# Access Compliance Report

## Public Rights-of-Way

Intersection ID: 6787	Main Street: N_GRAHAM_ST	Cross Street: PRINCESS_ST	Location: S
ADA ID: BE238D2FE312	Ramp Type: Perp	Initial Pass/Fail: Fail	Overall Compliance: No
Severity Score: 21.25			
Codes/Mitigation Info/Possible Solution		Field Measurements/Component Compliance

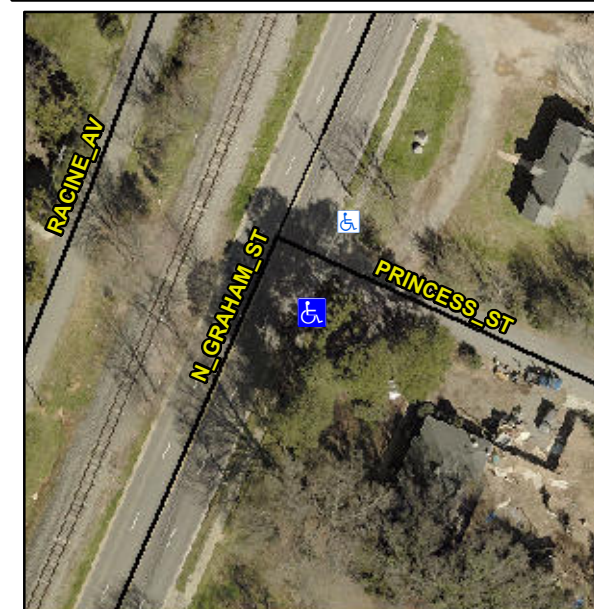
**Not Found, R304.5.1, R304.2.2**

Compliance	Description	Data	Compliance	Description	Data
N/A	Ramp Length (in)	43.0	No	Ramp Slope (%)	9.3
No	Ramp Width (in)	42.0	Yes	Ramp XSlope (%)	1.3
N/A	Flare Type LT	N/A	N/A	Flare Type RT	N/A
N/A	Flare Slope LT (%)	N/A	N/A	Flare Slope RT (%)	N/A
N/A	Flare Traversable LT?	N/A	N/A	Flare Traversable RT?	N/A
N/A	Landing Length (in)	N/A	N/A	DWS Provided?	N/A
N/A	Landing Width (in)	N/A	N/A	DWS Contrast?	N/A
N/A	Landing Slope (%)	N/A	N/A	DWS Length (in)	N/A
N/A	Landing X Slope (%)	N/A	N/A	DWS Full Width?	N/A
N/A	Landing Curb? (Y/N)	N/A	N/A	DWS Offset (in)	N/A
N/A	Shared Landing?	N/A			
N/A	Gutter Ponding?	N/A	N/A	Gutter Slope (%)	N/A
N/A	Gutter Lip Ht (in)	2.0	N/A	Gutter X Slope (%)	N/A
N/A	Painted X Walk1?	No	N/A	Painted X Walk2?	N/A
	X Walk 1 Direction	To NE		X Walk 2 Direction	N/A
N/A	X Walk 1 Width (in)	N/A	N/A	X Walk 2 Width (in)	N/A
	X Walk 1 Slope (%)	2.8		X Walk 2 Slope (%)	N/A
	X Walk 1 X Slope (%)	1.8		X Walk 2 X Slope (%)	N/A

**Remove & Replace Entire Ramp.**
